**SYDNEY NORTH PLANNING PANEL
COUNCIL ASSESSMENT REPORT**

Panel Reference	2018SNH055
Application Number	DA2018/1574
LGA	Northern Beaches
Proposed Development	Construction of a mixed use development comprising three residential flat buildings, commercial use of a heritage listed building, car parking, infrastructure and landscaping
Land to be developed (Address)	Part Lot 11 DP 577062 23 Fisher Road, Dee Why NSW 2099
Owner	Hamptons By Rose Pty Ltd
Applicant	Hamptons By Rose Pty Ltd
Date of Application lodgement	25 September 2018
Number of Submissions	3
Recommendation	Approval
Regional Development Criteria (Schedule 7 of the SEPP (State and Regional Development) 2011)	Development with a Capital Investment Value (CIV) of more than \$30 million
List of all relevant s4.15(1) (a) matters	<ul style="list-style-type: none"> • Environmental Planning and Assessment Act 1979 • Environmental Planning and Assessment Regulations 2000 • State Environmental Planning Policy No. 55 – Remediation of Land • State Environmental Planning Policy No. 65 – Design Quality of Residential Apartment Development • State Environmental Planning Policy (Infrastructure) 2007 • Warringah Local Environmental Plan 201

Figure 2 – Building layout approved under development application DA2011/1274

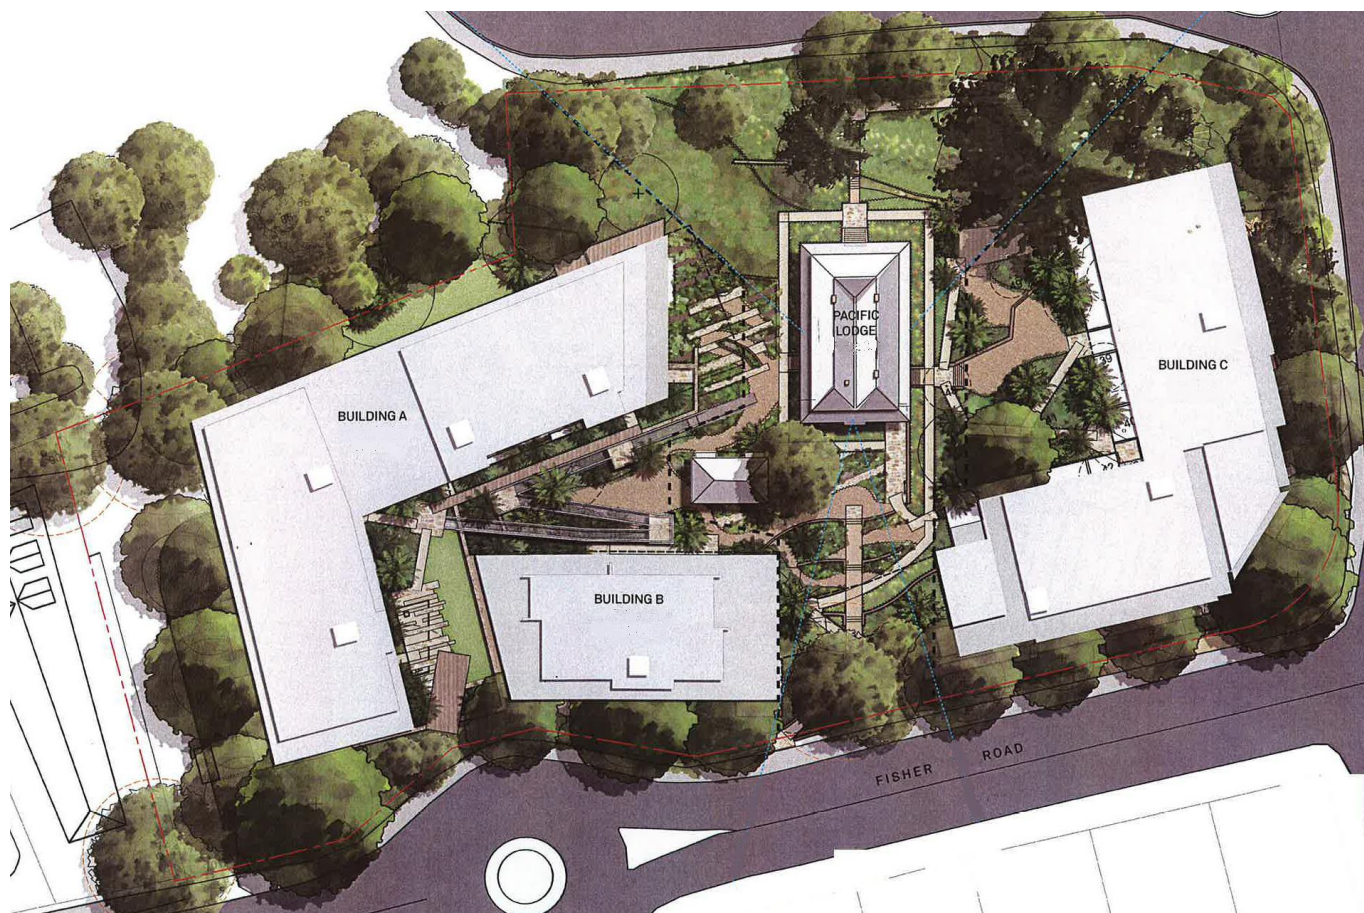
The submission also highlights that the development is generally consistent with the built form approved by the Sydney East Joint Regional Planning Panel in 2012 (DA2011/1274), which also relied upon a variation to the 13m maximum building height prescribed under the provisions of clause 4.3 of WLEP 2011. Whilst the current proposal seeks to introduce a pitched roof form (as opposed to the flat roof form approved in DA2011/1274), the footprint of the development and amount of floor space at the upper levels of the development are almost identical. Furthermore, through the refinement of the internal layout of each building, the maximum height and RL of the proposed development is marginally reduced compared to that previously approved.

Figure 6 – Extent of building envelope non-compliance (Building A)

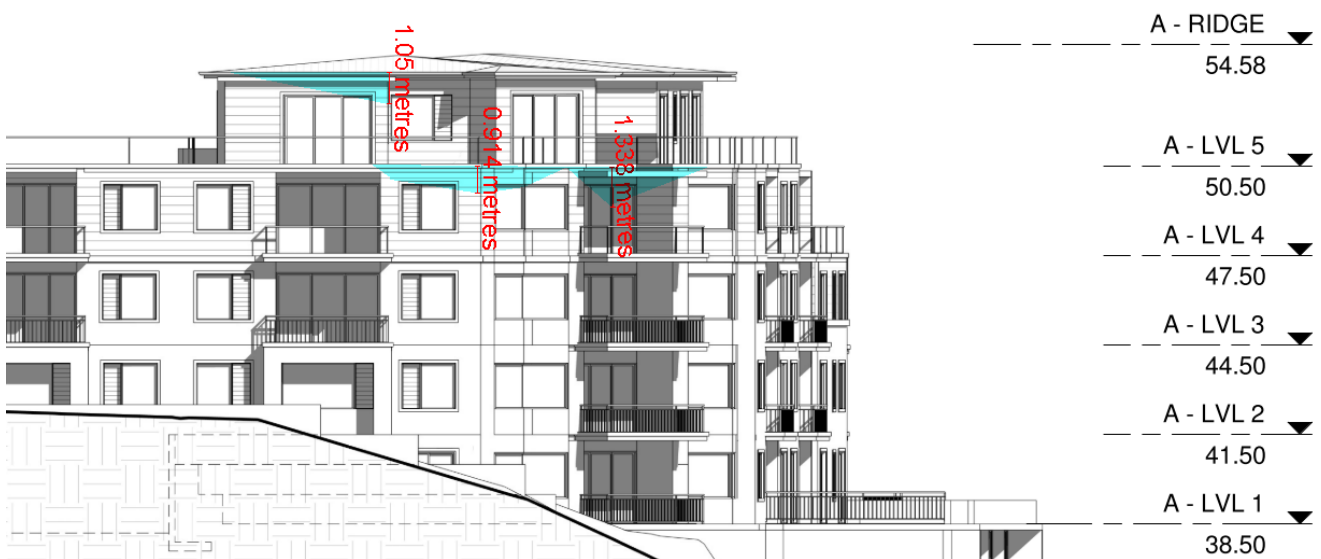
The proposed development is consistent with these development controls, with the exception of minor breaches of the building envelope on the eastern elevation of Building A, as shown in **Figure 6**.

The three minor areas of non-compliance are limited to a maximum height of 0.91m, 1.05m and 1.33m respectively. The breaches are limited in scale due to the articulated nature of the eastern elevation, will not contribute to excessive bulk and scale, and will not be visible from the public domain. Overall, the minor areas of non-compliance along the eastern elevation of Building A do not detract from consistency with these objectives of clause G10 of WDCP 2011.
